FORM APPROVED  
OMB NO. 1004-0135  
Expires: July 31, 2010**SUNDRY NOTICES AND REPORTS ON WELLS** JAN 13 2015  
*Do not use this form for proposals to drill or to re-enter an abandoned well. Use form 3160-3 (APD) for such proposals.*

CIMAREX ENERGY RESPECTFULLY REQUESTS APPROVAL TO CHANGE SURFACE CASING AND PRESSURE CONTROL EQUIPMENT SEE BELOW:

OPERATOR'S NAME:	Cimarex Energy Co. of Colorado
LEASE NO.:	NMNM-96208
WELL NAME & NO.:	Taos Federal 5H
SURFACE HOLE FOOTAGE:	0310' FSL & 0524' FWL
BOTTOM HOLE FOOTAGE:	0330' FNL & 0500' FWL
LOCATION:	Section 31, T. 24 S., R 27 E., NMPM
COUNTY:	Eddy County, New Mexico

Exhibit E-1 – 2000# BOP  
Taos Federal 5H  
Cimarex Energy Co. of Colorado  
31-24S-27E  
SHL 310' FSL & 524' FWL  
BHL 330' FNL & 500' FWL  
Eddy County, NM

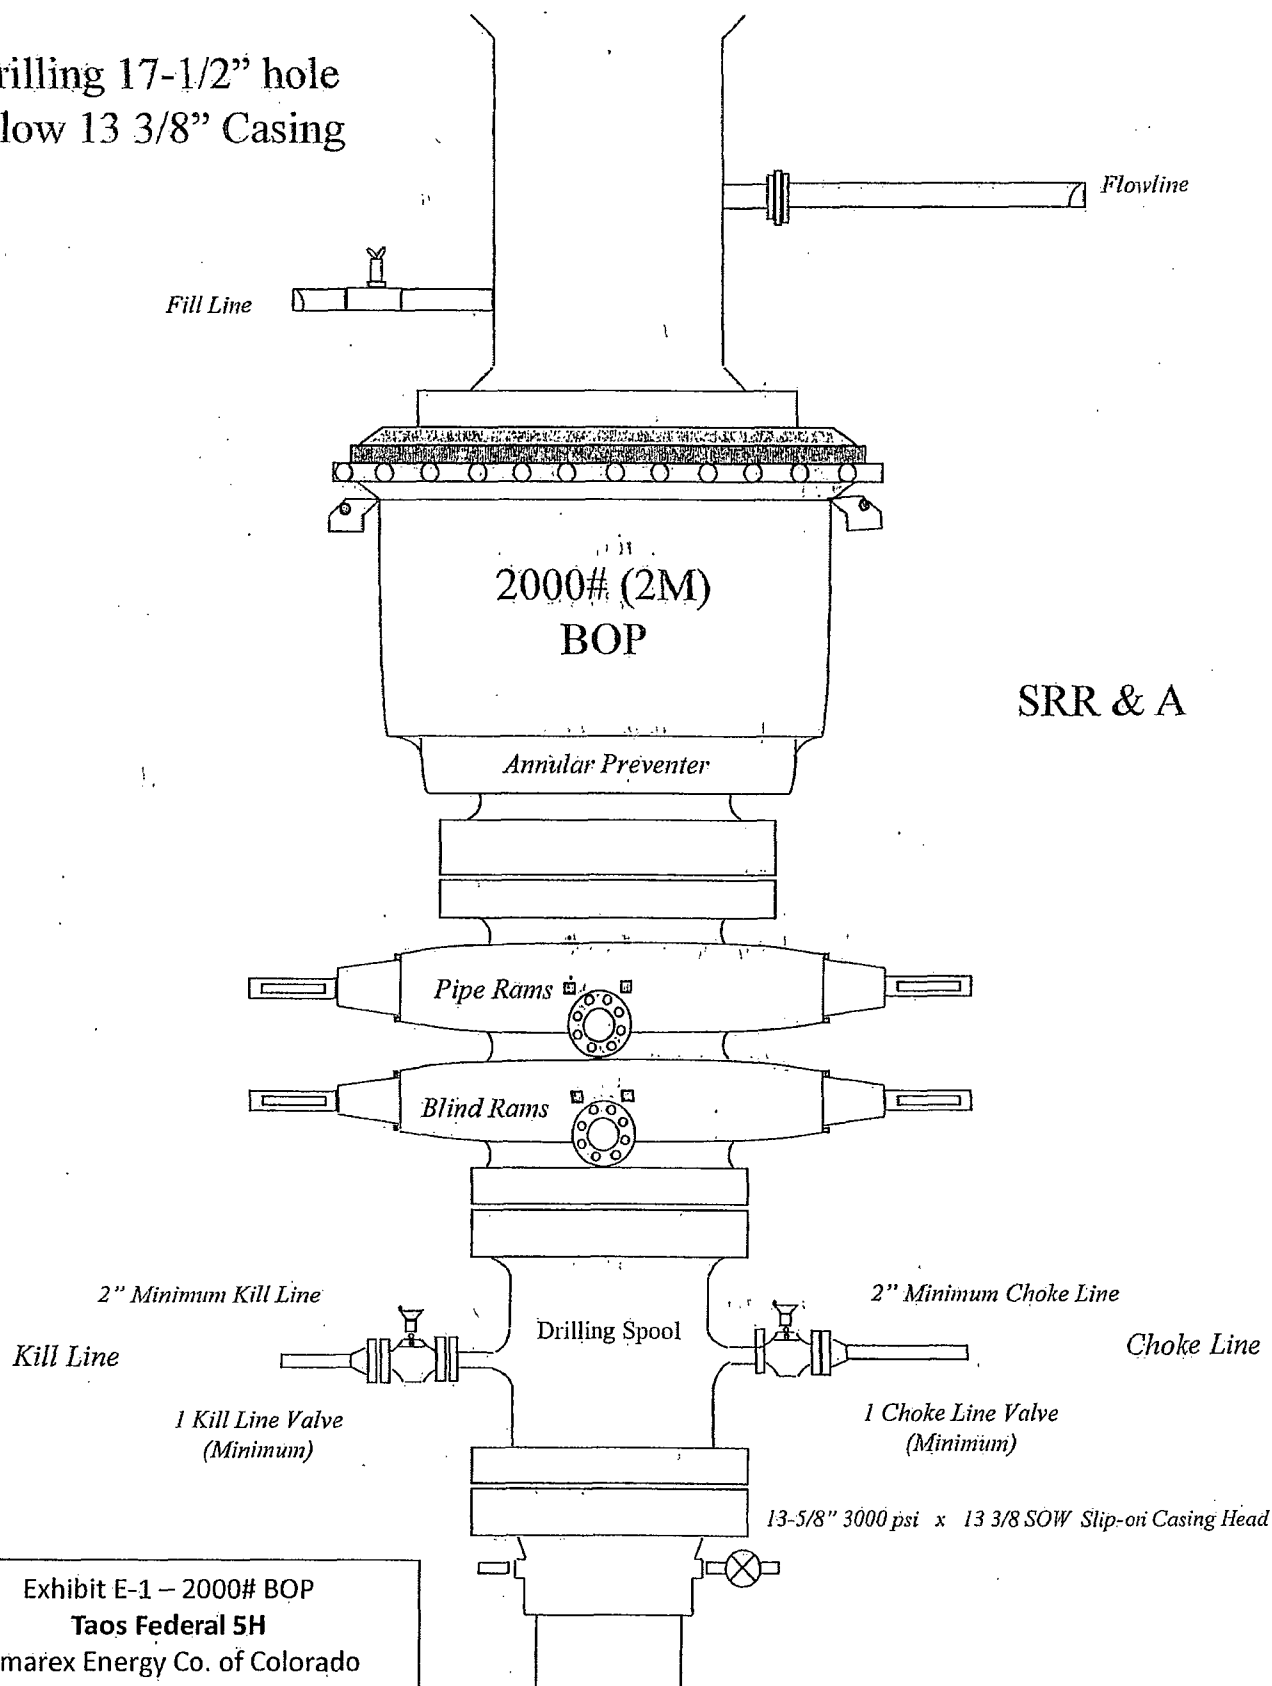
2M SYSTEM BELOW SURFACE AND 3M BELOW INTERMEDIATE

Intermediate casing  $(2,078 \times 8.33 \text{ lb/gal} \times 0.052) - (0.22 \times 2,078) = 443 \text{ psi}$

PLEASE SEE ATTACHED REVISED BOP

3. Minimum working pressure of the blowout preventer (BOP) and related equipment (BOPE) required for drilling below the surface casing shoe shall be **2000 (2M) psi**

Exhibit E-1 – 3000# BOP  
Taos Federal 5H  
Cimarex Energy Co. of Colorado  
31-24S-27E  
SHL 310' FSL & 524' FWL  
BHL 330' FNL & 500' FWL  
Eddy County, NM

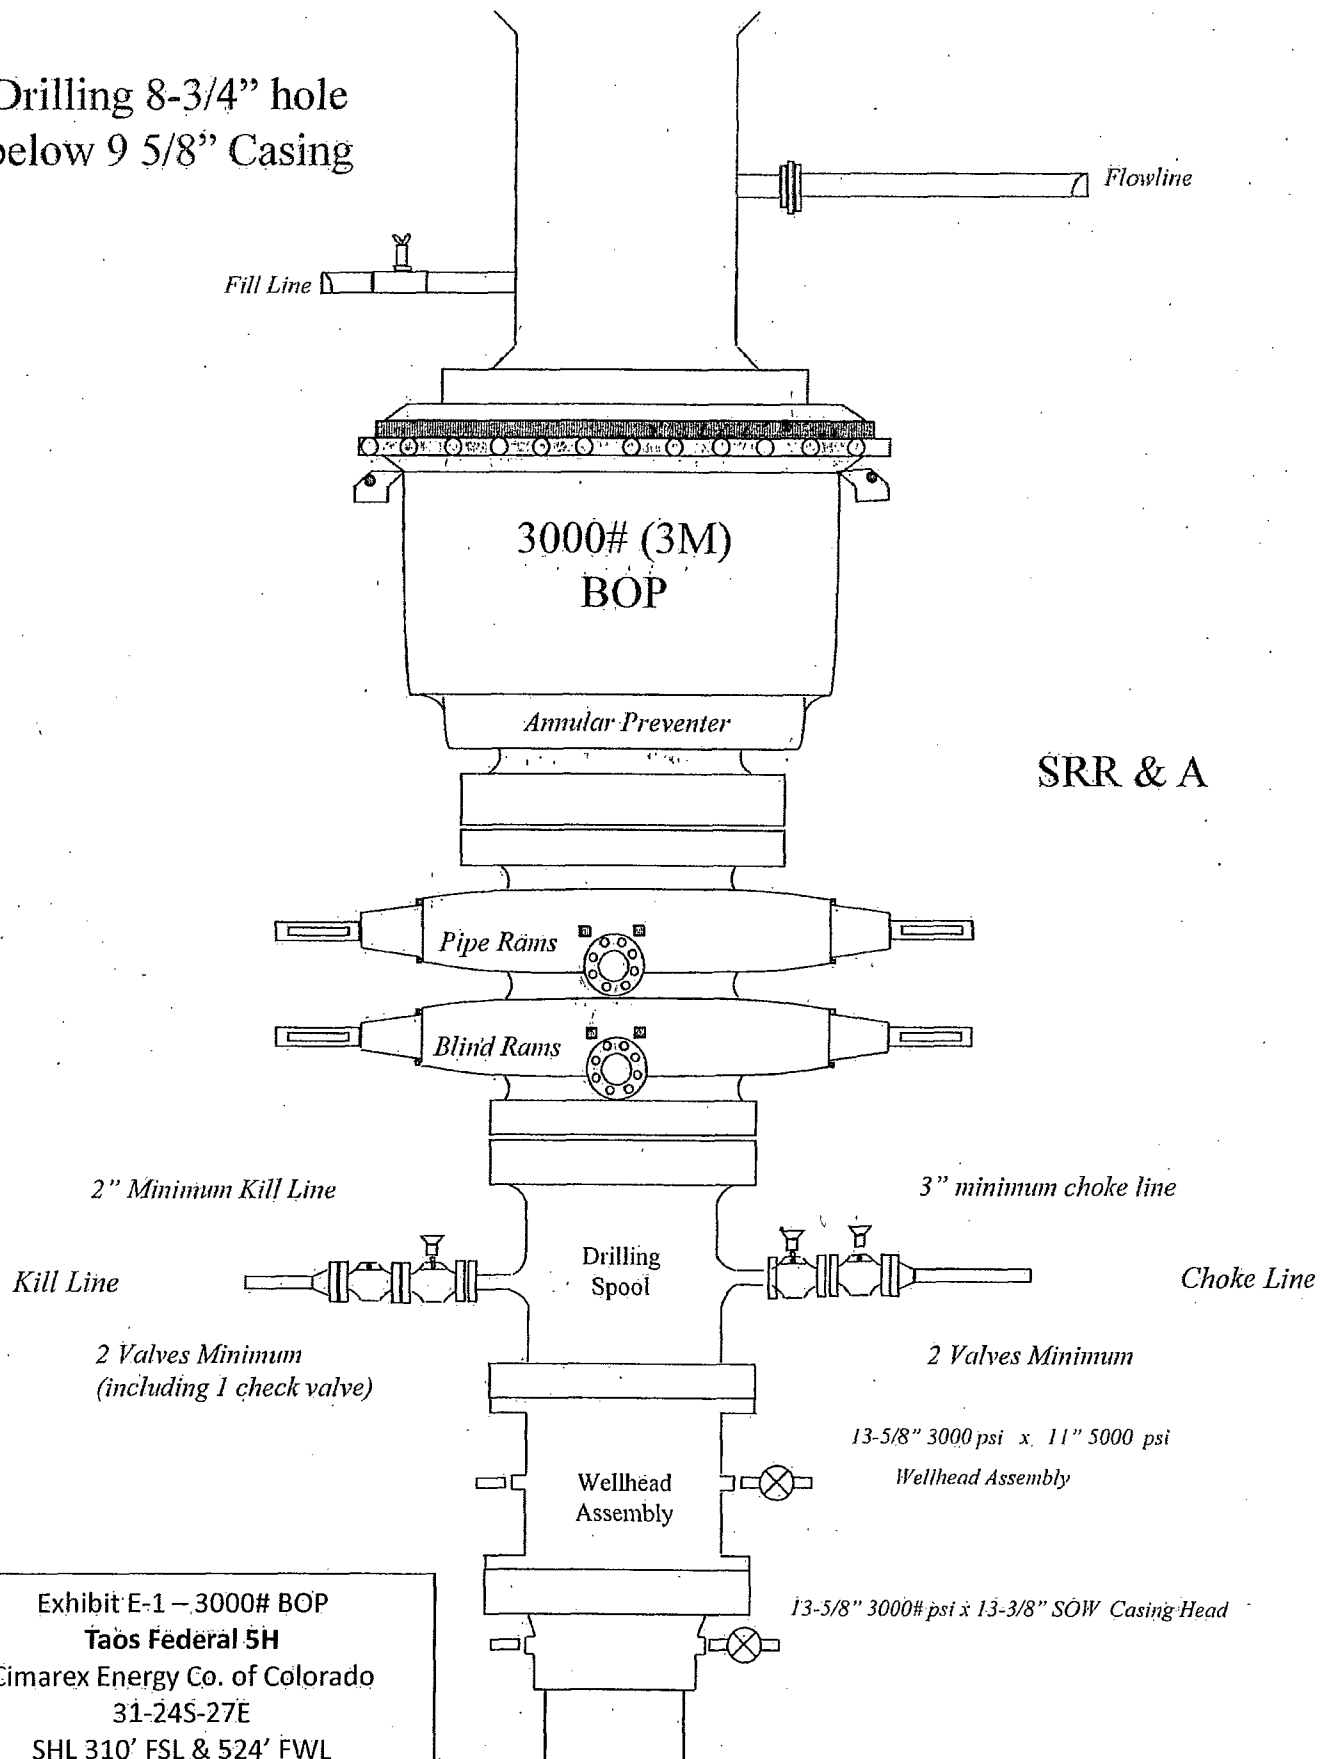
Production Casing  $(7362 \times 8.33 \text{ lb/gal} \times 0.052) - (0.22 \times 7362) = 1570 \text{ psi}$

4. Minimum working pressure of the blowout preventer (BOP) and related equipment (BOPE) required for drilling below the **9-5/8** intermediate casing shoe shall be **3000 (3M) psi**.
